Recall Bulletin

FMVSS NONCOMPLIANCE RECALL

SUBJECT: Fuel Label Compliance

MODELS: 2013-2014 Chevrolet Express, Silverado HD
2013 GMC Savana
2013-2014 GMC Sierra HD
Compressed Natural Gas Vehicles

Chevrolet Express/GMC Savana CNG Label Installation Instructions

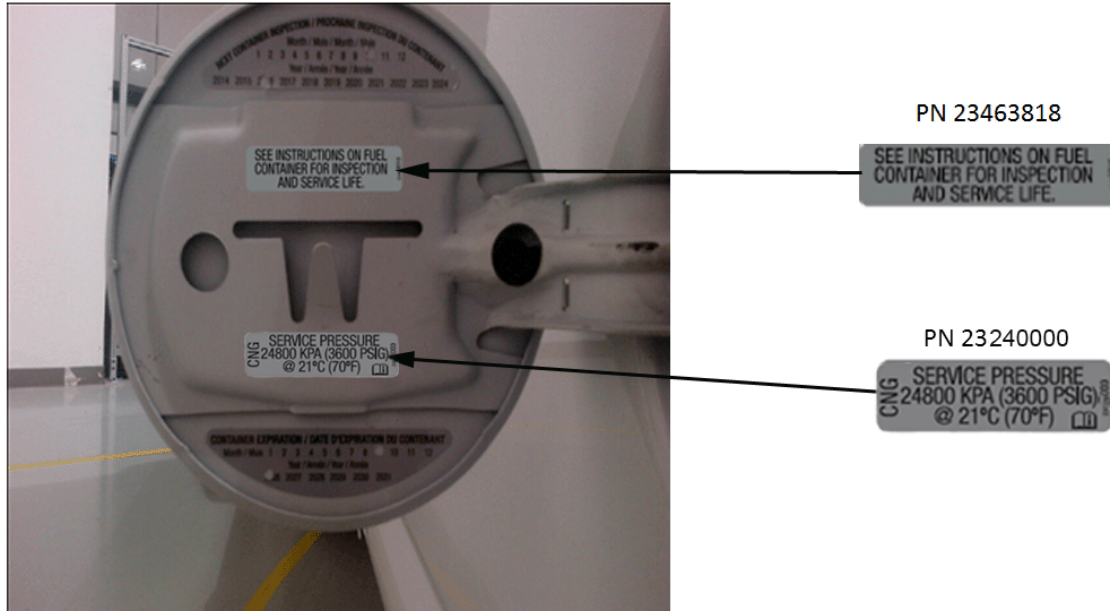
Note: Affix the provided labels to the location shown in the photograph as necessary.

1. Determine if label P/N 23240000 has been installed on the vehicle.
 - If label P/N 23240000 has been installed, reinstallation of that label is not required. Proceed to Step 2 and install label P/N 23463818.
 - If label P/N has NOT been installed, both labels will require installation. Proceed to Step 2 and install both labels.
2. Remove existing label and any residue using isopropyl alcohol. Dry the label surface with clean, lint free cloth. The label surface must be clean, dry and free of any contaminants. Do NOT place new label over an existing label.
3. Firmly hold the new label and peel protective liner from the back side, being careful not to touch or contaminate the adhesive with dirt or foreign matter.
4. Carefully align new label to the surface, press firmly and smooth out entire label ensuring corners are fully adhered.

Chevrolet Silverado/GMC Sierra CNG Label Installation Instructions

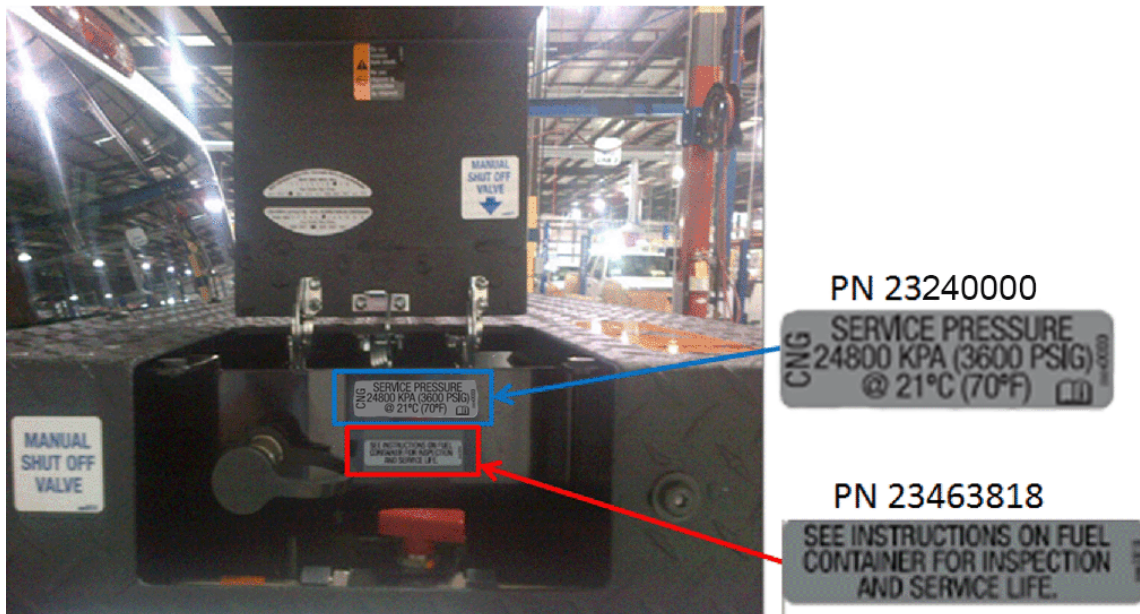
Note: Affix the provided labels to the location shown in the photograph as necessary.

1. Determine if label P/N 23240000 has been installed on the vehicle.
 - If label P/N 23240000 has been installed, reinstallation of that label is not required. Proceed to Step 2 and install label P/N 23463818.
 - If label P/N has NOT been installed, both labels will require installation. Proceed to Step 2 and install both labels.
2. Remove existing label and any residue using isopropyl alcohol. Dry the label surface with clean, lint free cloth. The label surface must be clean, dry and free of any contaminants. Do NOT place new label over an existing label.
3. Firmly hold the new label and peel protective liner from the back side, being careful not to touch or contaminate the adhesive with dirt or foreign matter.
4. Carefully align new label to the surface, press firmly and smooth out entire label ensuring corners are fully adhered.

Chevrolet Express/GMC Savana CNG Label Installation Instructions

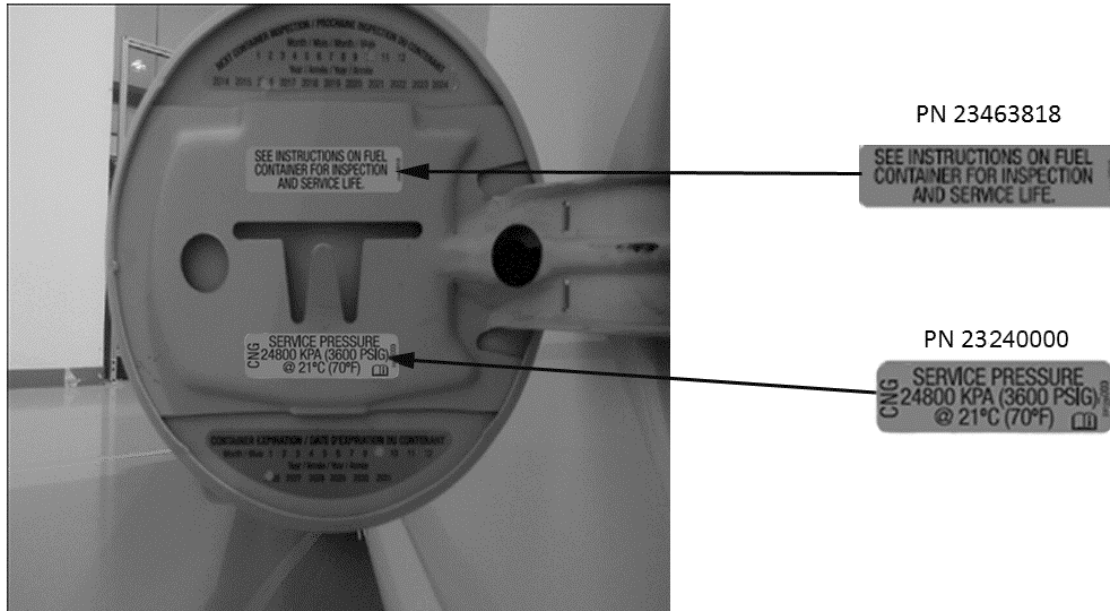
Note: Affix the provided labels to the location shown in the photograph as necessary.

5. Determine if label P/N 23240000 has been installed on the vehicle.
 - If label P/N 23240000 has been installed, reinstallation of that label is not required. Proceed to Step 2 and install label P/N 23463818.
 - If label P/N has NOT been installed, both labels will require installation. Proceed to Step 2 and install both labels.
6. Remove existing label and any residue using isopropyl alcohol (rubbing alcohol). Dry the label surface with a clean, lint free cloth. The label surface must be clean, dry, and free of any contaminants. Do NOT place the new label over the existing label.
7. Firmly hold the new label and peel the protective liner from the back side, being careful not to touch or contaminate the adhesive with dirt or foreign matter.
8. Carefully align the new label to the surface, press firmly and smooth out entire label ensuring corners are fully adhered.

Chevrolet Silverado/GMC Sierra CNG Label Installation Instructions

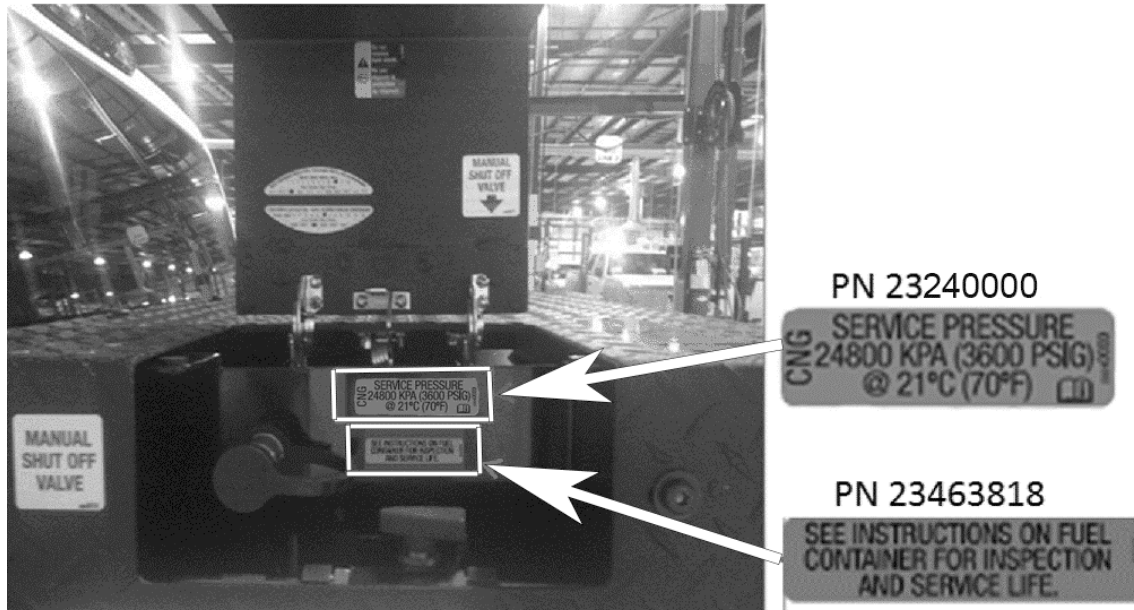
Note: Affix the provided labels to the location shown in the photograph as necessary.

5. Determine if label P/N 23240000 has been installed on the vehicle.
 - If label P/N 23240000 has been installed, reinstallation of that label is not required. Proceed to Step 2 and install label P/N 23463818.
 - If label P/N has NOT been installed, both labels will require installation. Proceed to Step 2 and install both labels.
6. Remove existing label and any residue using isopropyl alcohol (rubbing alcohol). Dry the label surface with a clean, lint free cloth. The label surface must be clean, dry, and free of any contaminants. Do NOT place the new label over the existing label.
7. Firmly hold the new label and peel the protective liner from the back side, being careful not to touch or contaminate the adhesive with dirt or foreign matter.
8. Carefully align the new label to the surface, press firmly and smooth out entire label ensuring corners are fully adhered.
